From: Singh, Sumeet
Sent: 11/7/2013 10:57:48 PM
To: sunil.shori@cpuc.ca.gov (sunil.shori@cpuc.ca.gov)
Cc: Yura, Jane (/O=PG&E/OU=CORPORATE/CN=RECIPIENTS/CN=JKY1); Redacted
Redacted Doll, Laura
(/O=PG&E/OU=CORPORATE/CN=RECIPIENTS/CN=LRDD)
Bcc:
Subject: RE: Line 147 Follow-up Items (Week of October 28, 2013)

From: Singh, Sumeet
Sent: Saturday, November 02, 2013 12:33 PM
To: 'sunil.shori@cpuc.ca.gov'
Cc: Yura, Jane; Doll, Laura; [Redacted]
Subject: Line 147 Follow-up Items (Week of October 28, 2013)

5. Regulator Station B43 Redacted - Complete

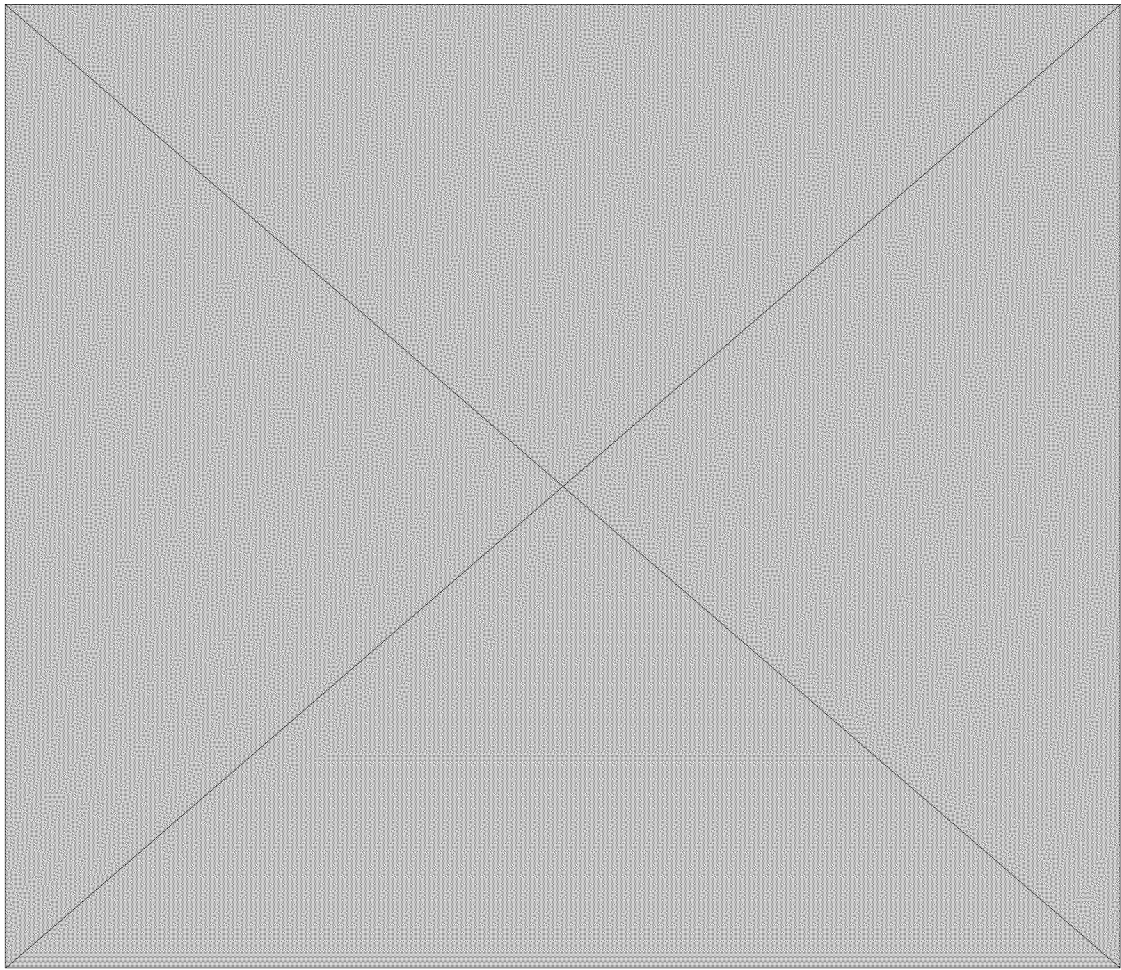
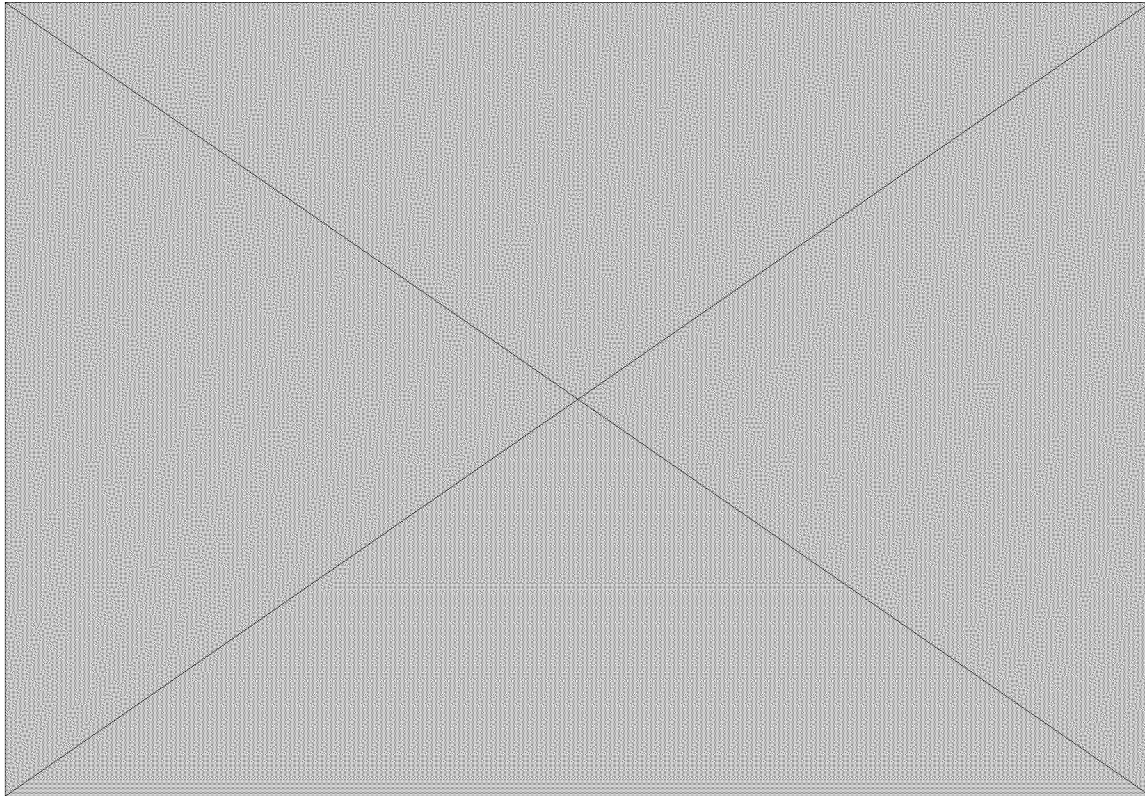
Based on your site visit, you identified an aboveground district regulator station susceptible to potential vandalism as the valves were not locked and there was no fence around the station. Based on a follow-up site visit performed by our field technicians, we installed locks on all valves on 11/1 and a temporary fencing will be installed on 11/4. The installation of permanent fencing will require permitting from various environmental agencies; hence, taking significantly longer to implement which we will continue to pursue. I will provide you with the associated documentation as it becomes available.

Please refer to the attached pictures below.
